Form 3160-5 (June 2019)	UNITED STATES DEPARTMENT OF THE INTERIOR BUREAU OF LAND MANAGEMENT	FORM APPROVED OMB No. 1004-0137 Expires: October 31, 2021
<b>SUNDRY NOTICES AND REPORTS ON WELLS</b> <i>Do not use this form for proposals to drill or to re-enter an abandoned well. Use Form 3160-3 (APD) for such proposals.</i>		5. Lease Serial No. NMNM28881
		6. If Indian, Allottee or Tribe Name

Jupiter 30 Fed Com 712H API #: 30-025-52721

EOG respectfully requests an amendment to our approved APD for this well to reflect the following changes:

## PECOS DISTRICT DRILLING CONDITIONS OF APPROVAL

Revised Wellbore

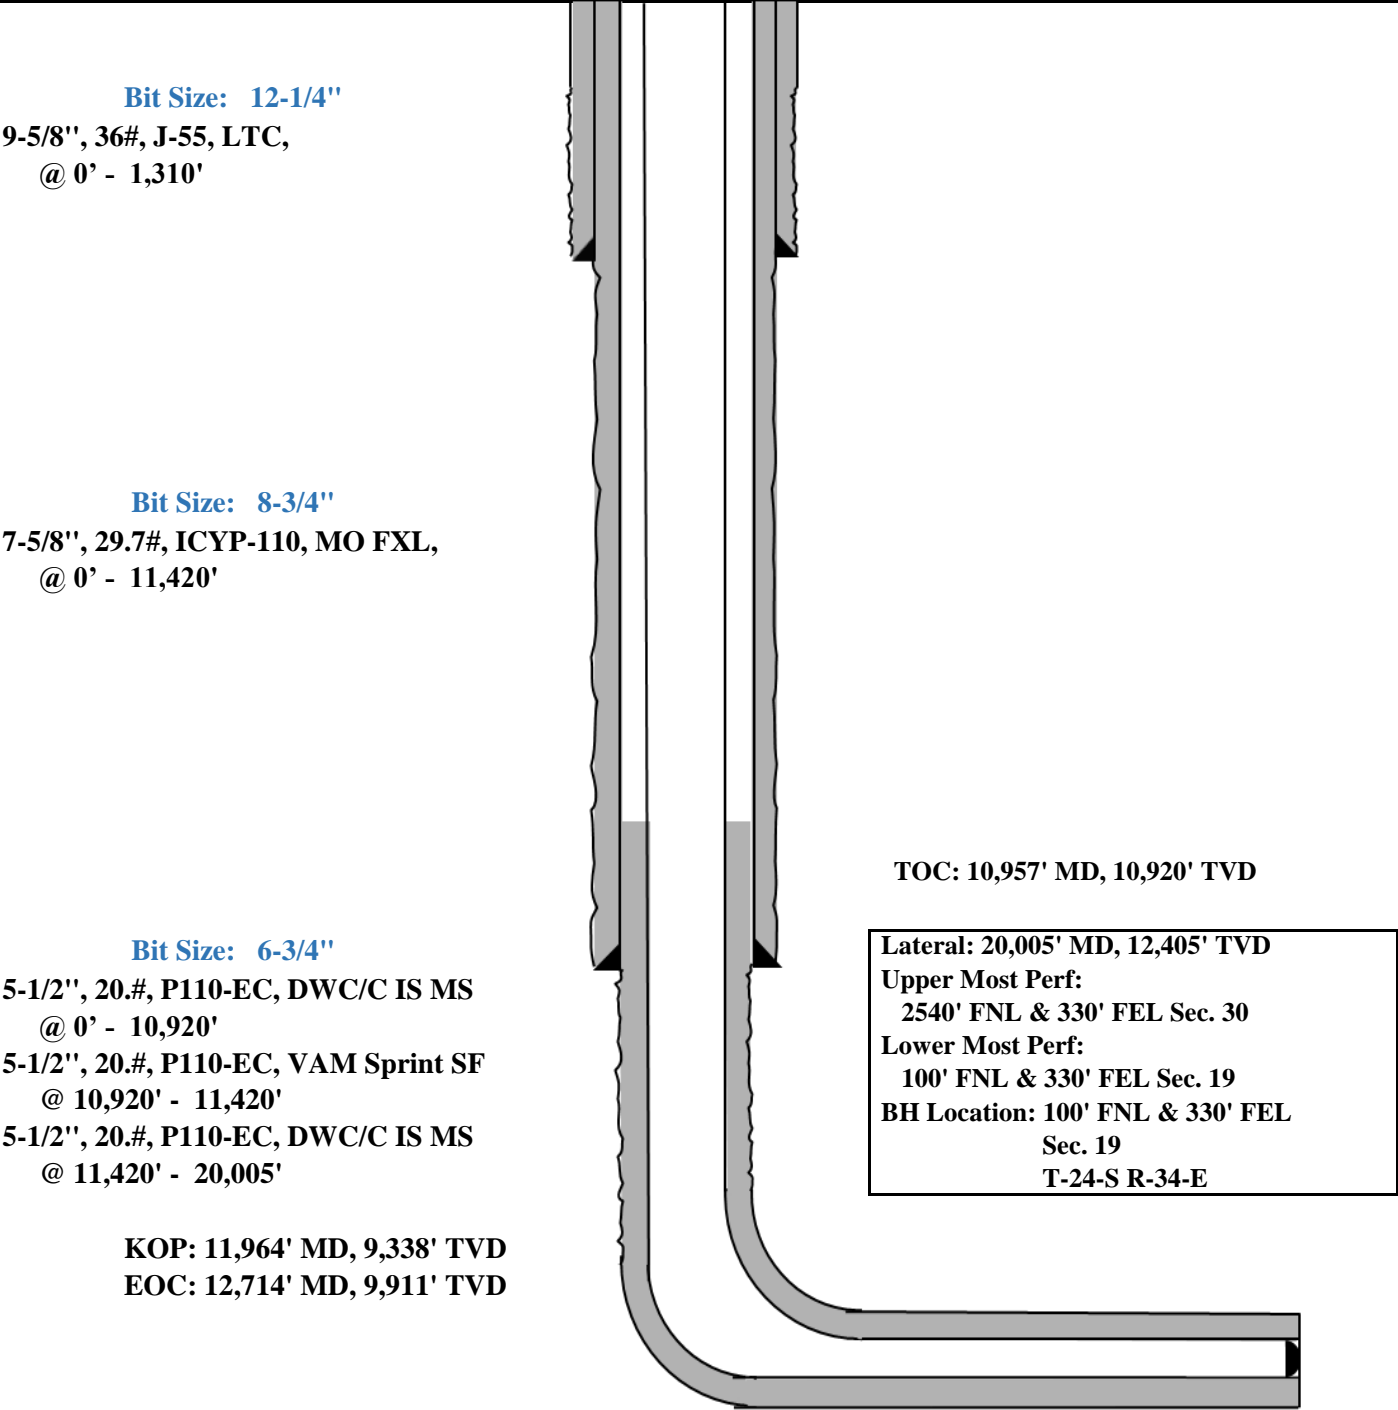
Change BHL from T-24-S, R-34-E, Sec 19, 100' FNL, 1650' FEL, Lea Co., NM,  
to T-24-S, R-34-E, Sec 19, 100' FNL, 330' FEL, Lea Co., N.M.

Update casing and cement program to current design.

Variance is requested to waive the centralizer requirements for the 7-5/8" casing in the 8-3/4" hole size. An expansion additive will be utilized, in the cement slurry, for the entire length of the 8-3/4" hole interval to maximize cement bond and zonal isolation.

Variance is also requested to waive any centralizer requirements for the 5-1/2" casing in the 6-3/4" hole size. An expansion additive will be utilized, in the cement slurry, for the entire length of the 6-3/4" hole interval to maximize cement bond and zonal isolation.

Variance is also requested to waive the annular clearance requirements for the 5-1/2" casing by 7-5/8" casing annulus to the proposed top of cement.
